UNITED STATES  
NUCLEAR REGULATORY COMMISSION  
WASHINGTON, D. C. 20555

TURKEY POINT PLANT UNIT NO. 3

Amendment No. 123  
License No. DPR-31

ATTACHMENT TO LICENSE AMENDMENT

FIGURE 6.2-1  
BFF-SITE ORGANIZATION FOR FACILITY  
MANAGEMENT AND TECHNICAL SUPPORT

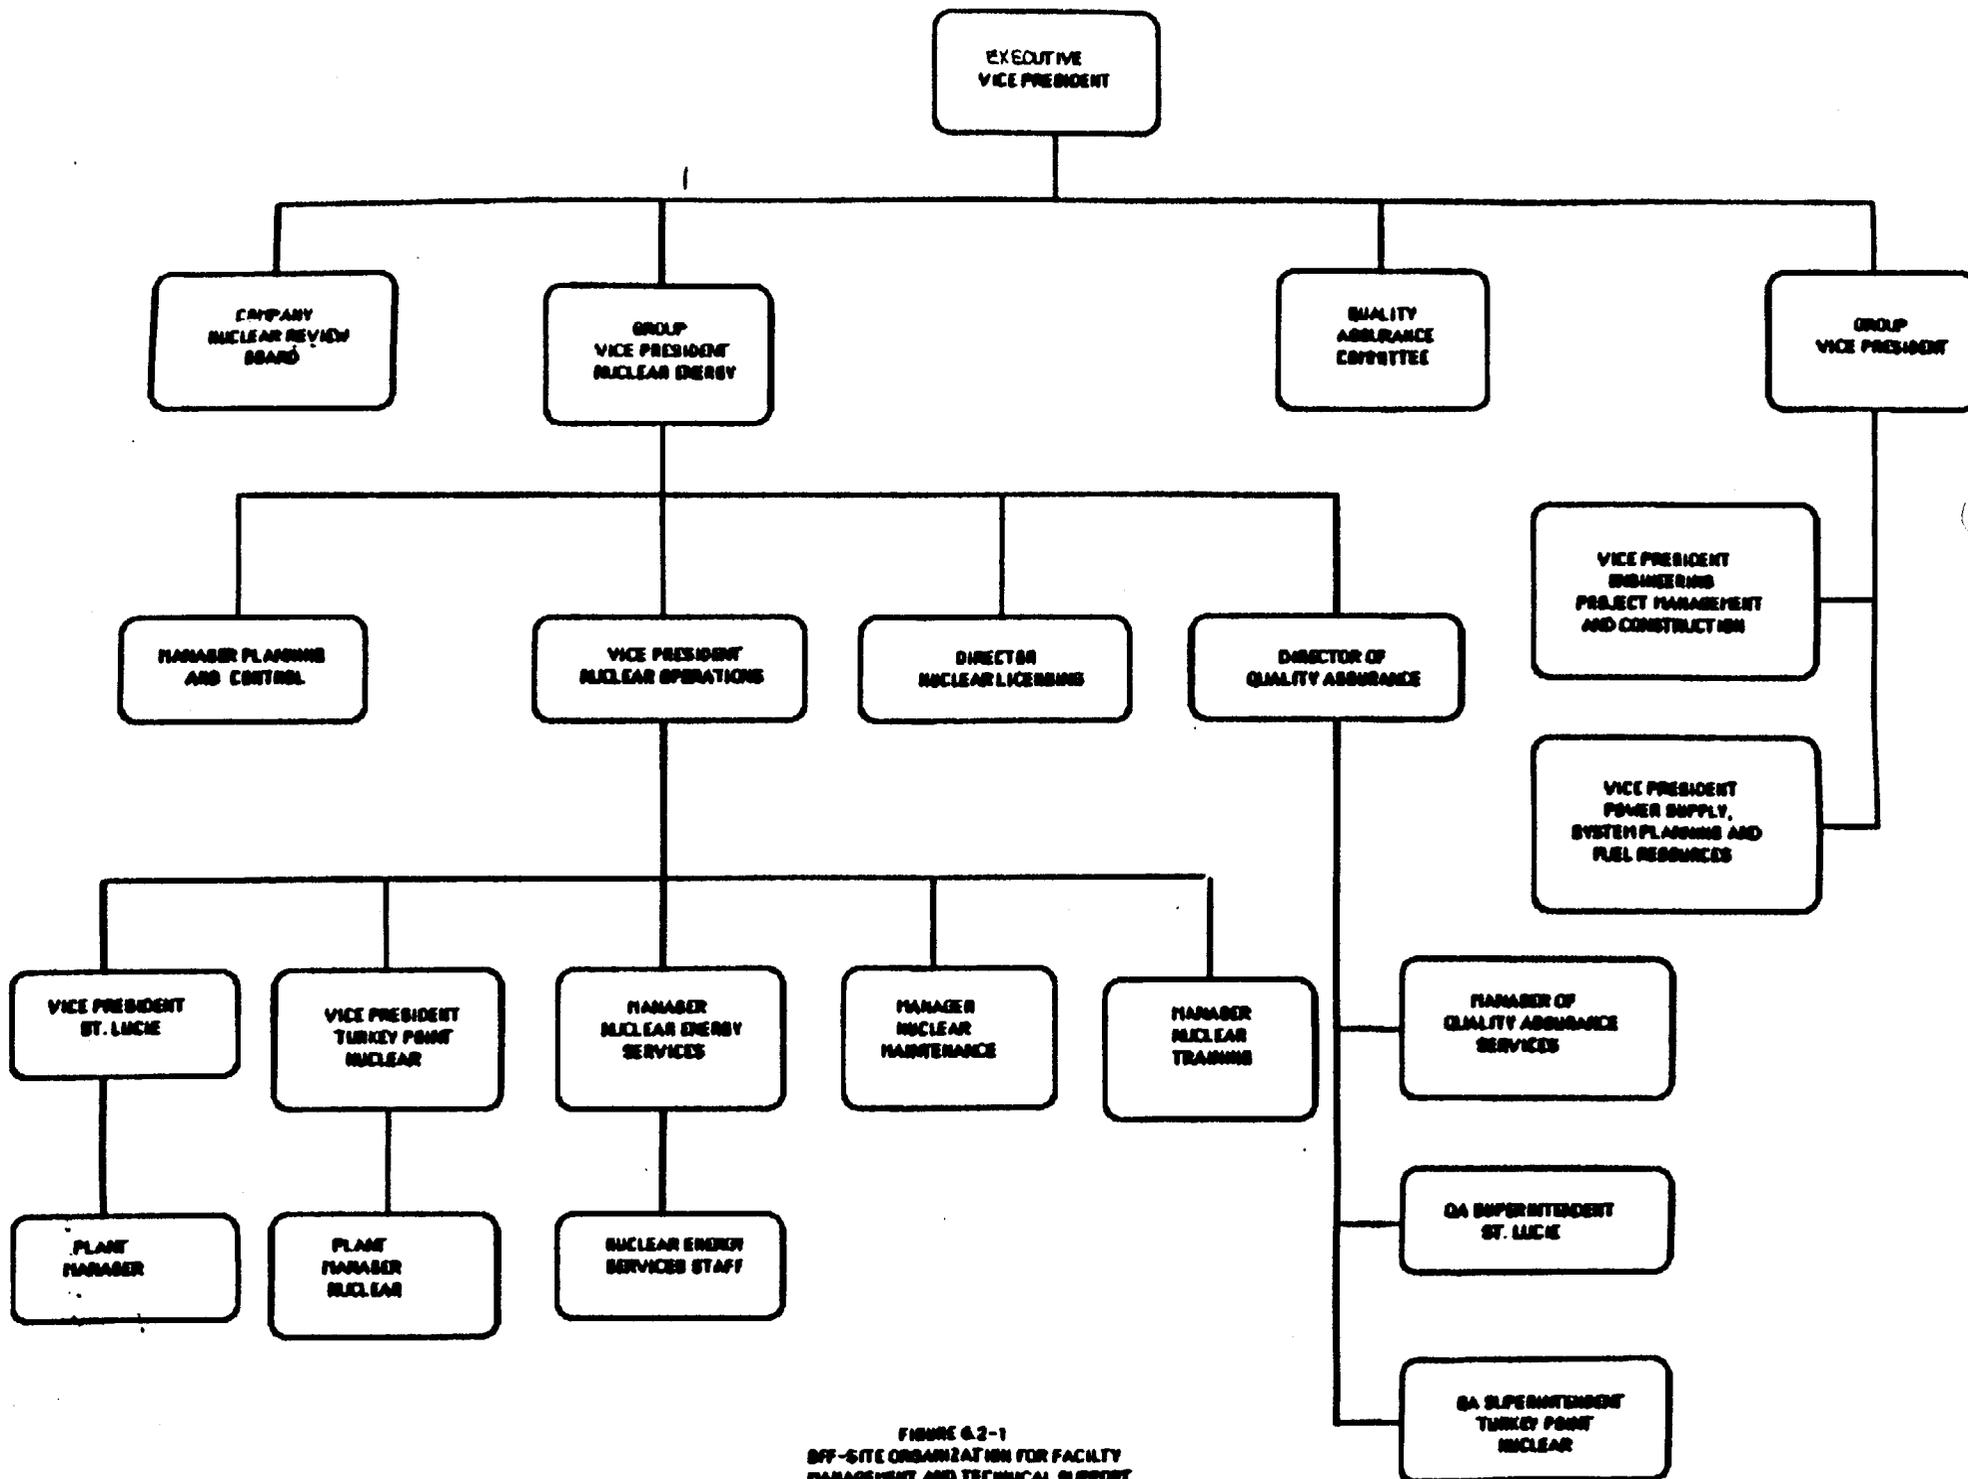
Pages 6-6, 6-7, 6-8, 6-9, 6-10 and Figures 6.2-1 and 6.2-2. The additions include a Group Vice President for the engineering, project management, construction, power supply, system planning and fuel resources areas, and a Site Engineering Manager reporting to the Vice President Turkey Point Nuclear. The Group Vice President replaced the Power Plant Engineering Principal Engineer as a member of the Company Nuclear Review Board (CNRB). The composition of the CNRB (6.5.2.2, Page 6-9) is changed to reflect this. Specification 6.5.2.3 is revised to reflect the NRC staff's current position on the

We conclude that the organization structure changes as discussed above do not diminish FPL's ability to safely operate the Turkey Point Units 3 & 4 and the proposed modifications to Figures 6.2-1 and 6.2.-2 to reflect these changes are acceptable. The corporate position titles of the designated CNRB members are such that the incumbents are expected to be qualified to perform the independent review functions and these changes are therefore acceptable.
